Waste Management Facility, 2-4 Hale St, Botany Landscape Concept Design Report

1.0 Response to Comments

7.0 Landscape Plan

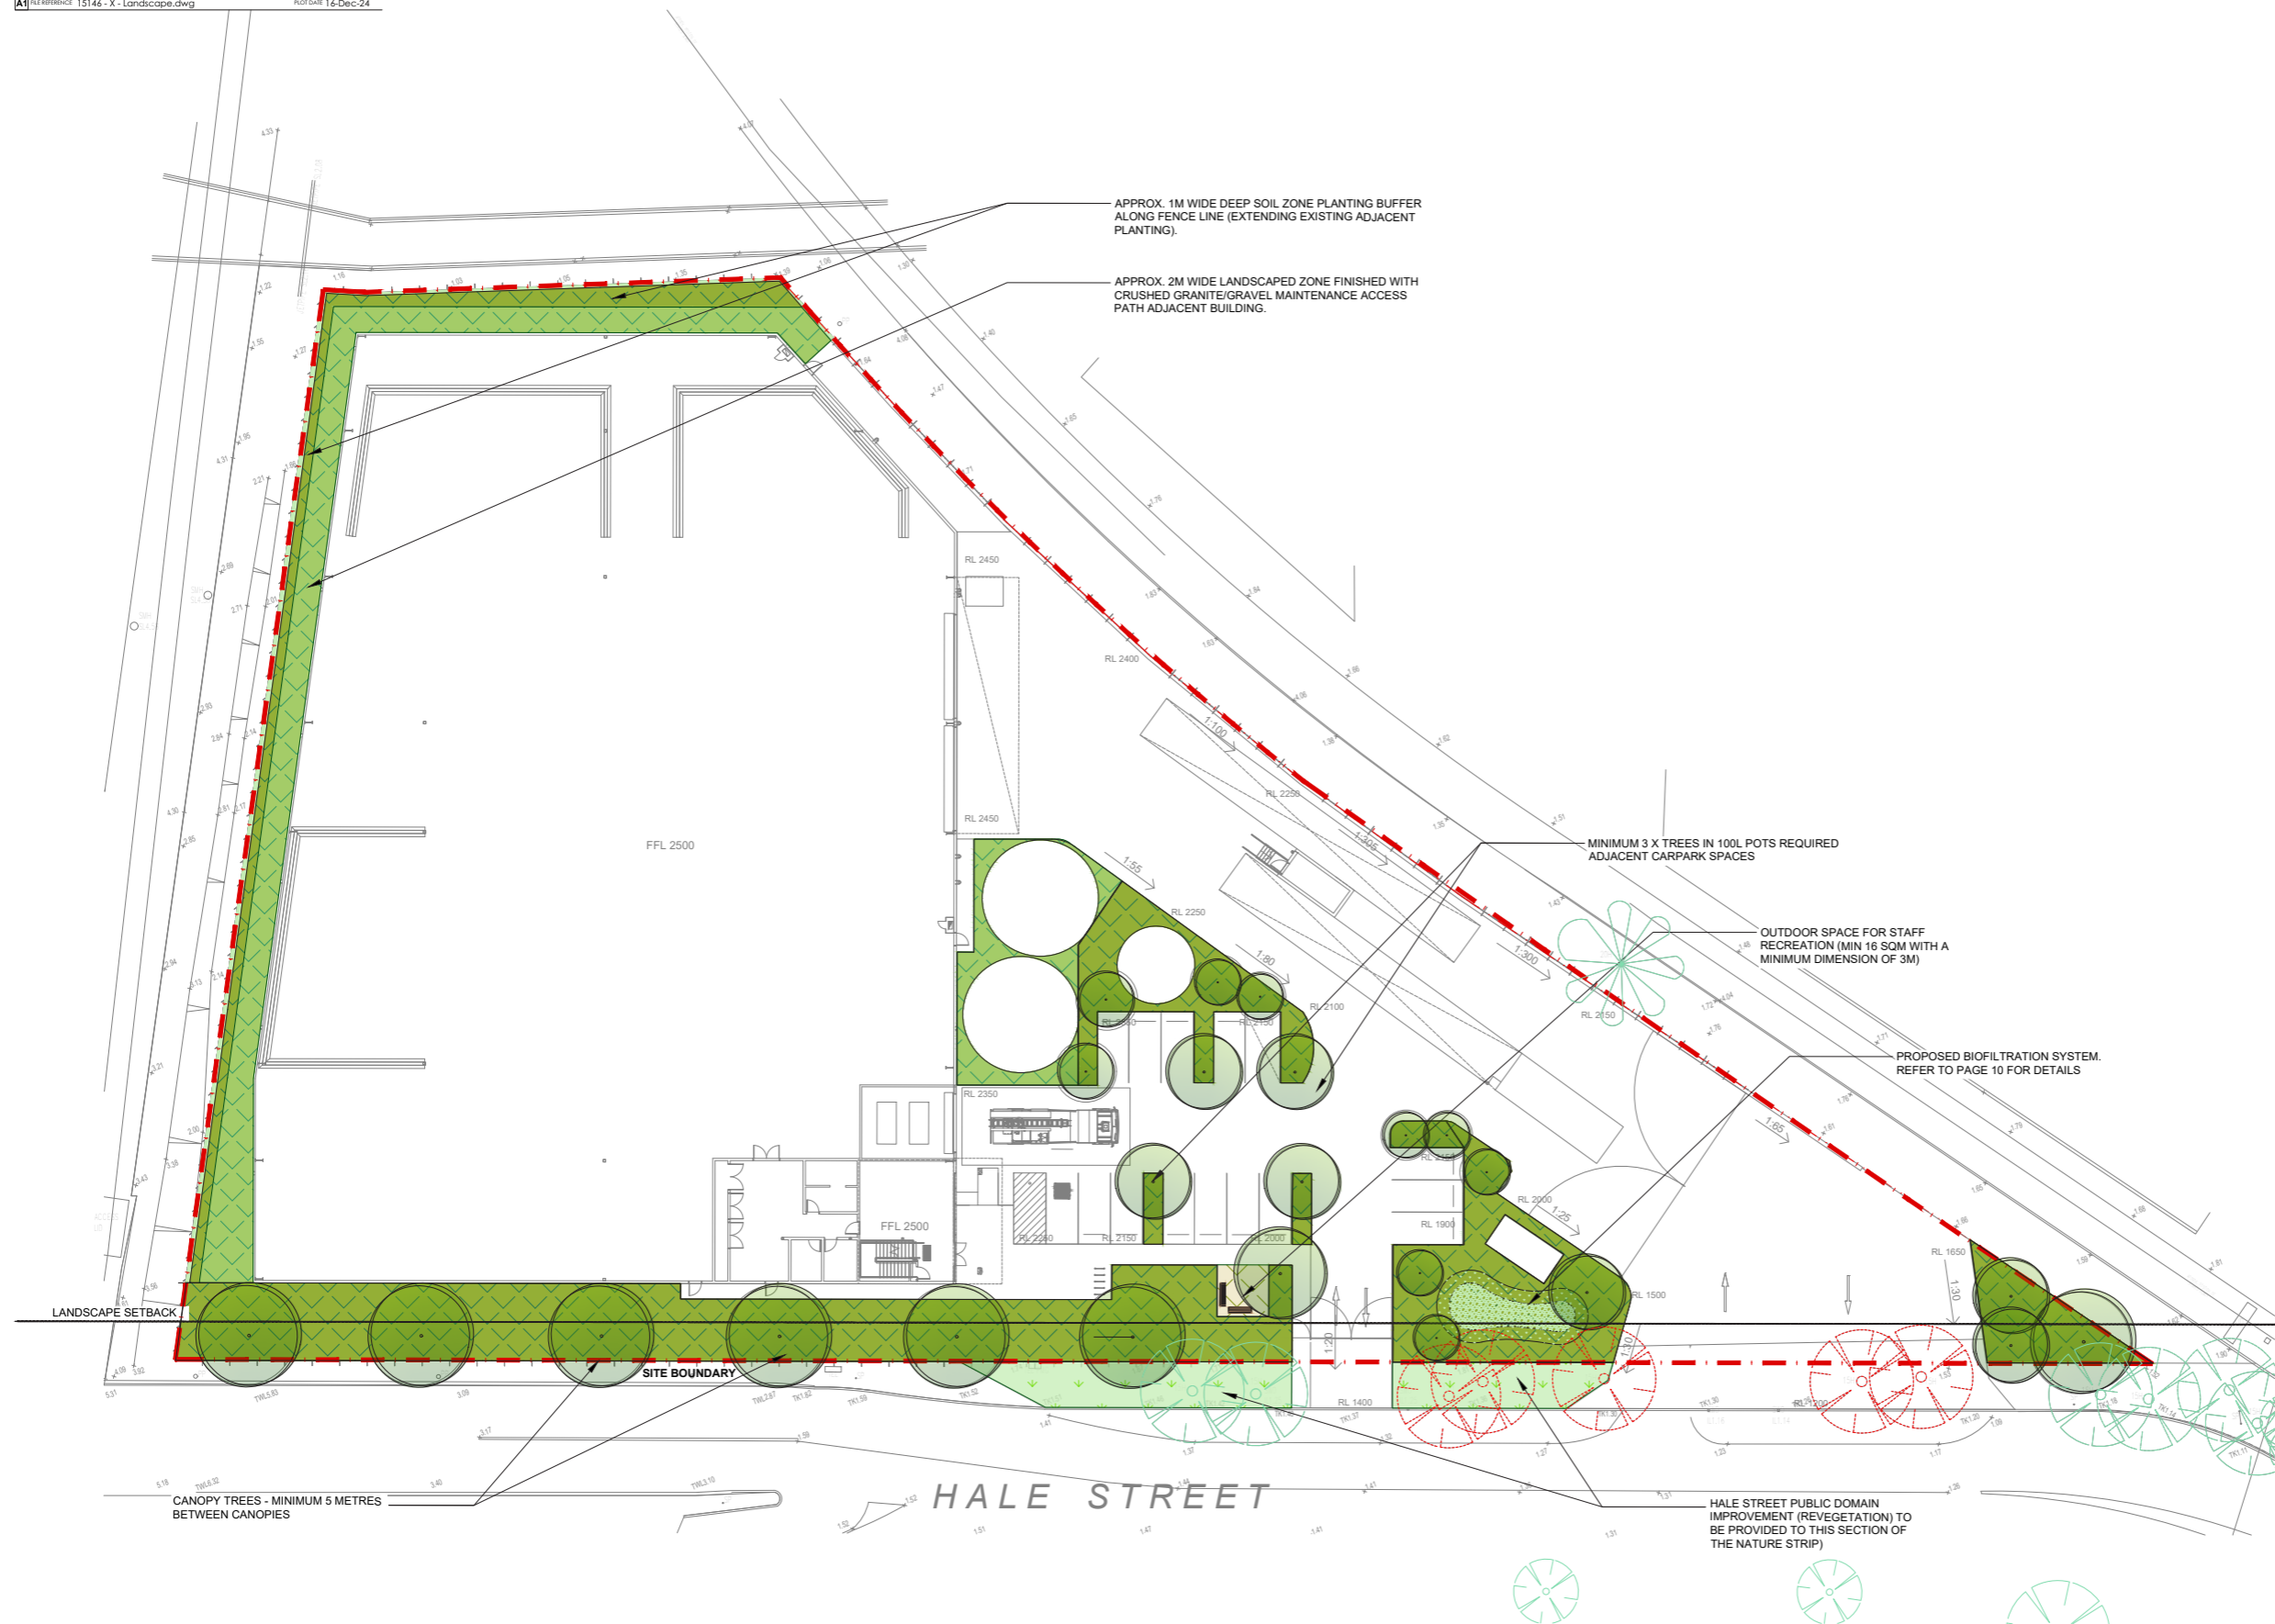
DPHI COMMENT		
DPHI COMMENT	RESPONSE	ADDRESSED ON PAGE:
Inconsistencies The Landscape Concept Design prepared by CJ Arms dated 19 April 2024 includes inconsistencies with respect to the number of semi-mature Casuarina glauca (She Oaks) to be removed, in some places it says four trees will be removed, and in others it indicates five trees will be removed. Recommendations: The Landscape Concept Design must be revised to confirm the total number of trees to be removed as a result of the development.	We confirm these inconsistencies have been rectified. Five trees will be removed as indicated on the Existing and Demolition Landscape Plan, and the Landscape Plan.	6.0 Existing and Demolition Landscape Plan. PG 8 7.0 Landscape Plan. PG 9
COUNCIL COMMENT		
COUNCIL COMMENT	RESPONSE	ADDRESSED ON PAGE:
The landscape concept plan identifies areas of the side and rear setbacks as contributing to the landscaped area. It includes these areas in the calculation of the total landscaped area on the site. However, the plans indicate these side and rear setbacks are to be entirely "compacted gravel". It is not considered that a plain compacted gravel surface satisfies the intention, functions and definition of landscaped area.	We have introduced a planting buffer along the western and northern landscaped areas. This buffer will be planted around the perimeter of the site with the area between the planting and building to be finished with a 2m wide permeable crushed granite or gravel to allow maintenance access for the fence, building and landscape.	7.0 Landscape Plan. PG 9

The proposal does not identify any improvements to the Hale Street public domain. The determination should include a requirement for landscaping improvements to be made to the street.	Hale street public domain improvement/revegetation will be provided to the section of nature strip indicated in the Landscape Plan.	7.0 Landscape Plan. PG 9
It appears that no outdoor space for staff is provided. The Bayside DCP 2022 (6.4: C.6) requires that staff are provided with an outdoor area for recreation, being at least 16m2 in size, with a minimum dimension of 3 metres. At least 6m2 of the area should receive direct sunlight for the hours between 10am and 2pm in mid-winter and be shaded in summer. The recreation area should not be in the landscaped setbacks.	We have created a 16 sqm space (4m X 4m) to achieve this requirement in the revised architectural masterplan.	7.0 Landscape Plan. PG 9
It appears that the car park could be further landscaped. The Bayside DCP 2022 at 3.7.5 requires that at-grade carparks have generous landscaping and tree canopy planting, including:	We have proposed a reconfiguration of the carparking area to maximise canopy coverage in the carpark.	7.0 Landscape Plan. PG 9

1 Tree per 5 car spaces to achieve 50% canopy coverage at maturity to combat urban heat impacts.	There are a minimum of 3 trees (100L pots) proposed within the carpark area (15 car spaces)	7.0 Landscape Plan. PG 9
The car park should feature areas of landscaping to break up functional areas of the car park including pedestrian crossings and entry areas. Contrasting materials should be used to help define these elements visually.	The architectural masterplan and associated Landscape Plan have been updated to address these concerns.	7.0 Landscape Plan. PG 9
Tree pits should provide adequate dimensions to cater for tree roots, future tree growth and to provide adequate moisture penetration and aeration of the root zone.	Noted	
The minimum pot size for trees in the parking area is 100 litres	Noted	
Further details are set out in the Bayside Landscaping Technical Specification.	Noted
